**City of Ramsey**  
**Agenda**  
**Environmental Policy Board (EPB)**  
**Monday, October 20, 2025**  
**6:30 pm**  
**Council Chambers, 7550 Sunwood Drive NW**

Consider Natural Resources Aspects of a Site Plan for CorTrust Bank (Project No. 25-123); Case of CorTrust Bank

**CORTRUST BANK**  
RAMSEY, MINNESOTA

L1.1 OVERALL LANDSCAPE PLAN.pdf V1 - Changemark Notes ( 6 Notes )

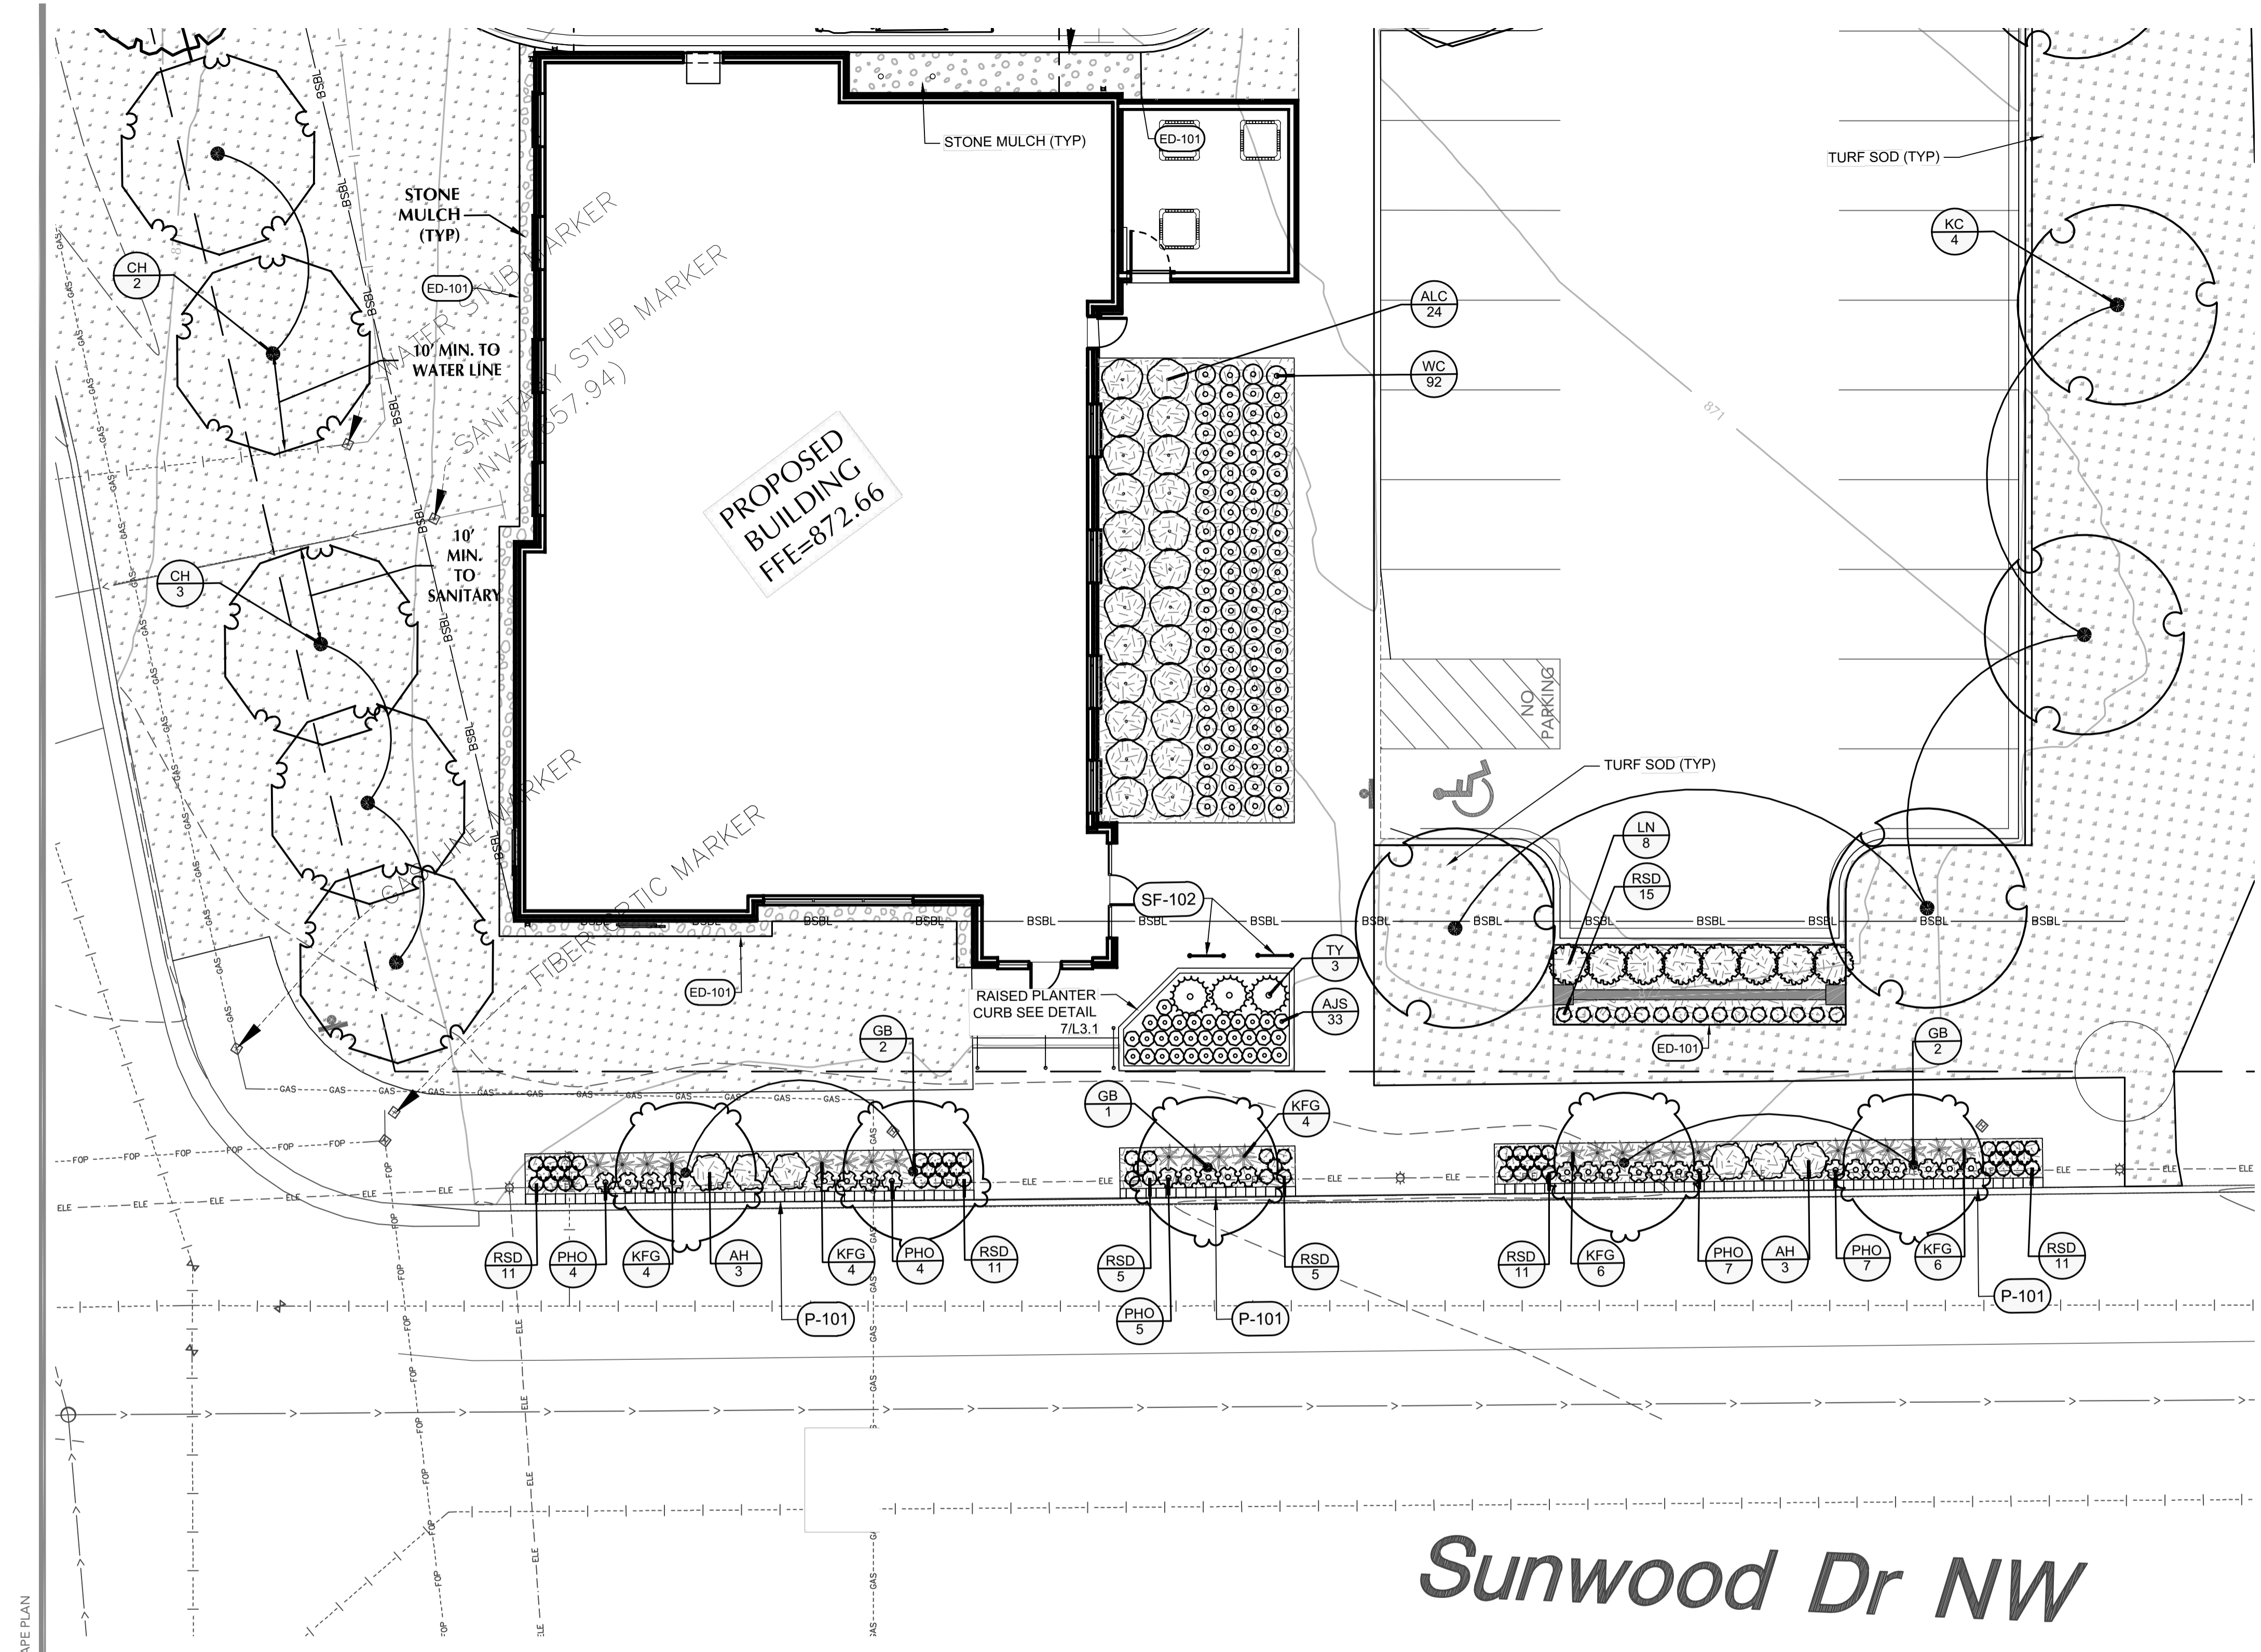
Along Zeolite Street, there shall be a boulevard at least six (6) feet in width and a concrete sidewalk that is at least six (6) feet in width.

In the boulevard, there shall be street trees planted at a spacing not more than 35 feet on center.

Acceptable species in the boulevard include the following: Bicolor Oak, Princeton Elm, Accolade Elm, Autumn Blaze Maple, Skyline Honeylocust, Kentucky Coffeetree, or River Birch (single stem only).

A 3-5 year maintenance plan is required if using this native seed mix. Please submit the maintenance plan for review. The maintenance plan must outline what maintenance activities are necessary, frequency, and time of year. A copy of the maintenance plan must be provided to the bank so that they know what they are required to do to ensure proper establishment.

With boulevard trees being required, it may not make sense to keep all these trees here, so it would be optional to retain them or they could be eliminated.

Why not extend irrigation to these sodded areas? They will be highly visible to all customers coming to the bank via vehicles.

The decorative knee wall needs to be extended to provide screening of the entire width of the parking lot from Sunwood Drive. The height of the knee wall shall be not less than three (3) feet and not more than 4.5 feet in height.
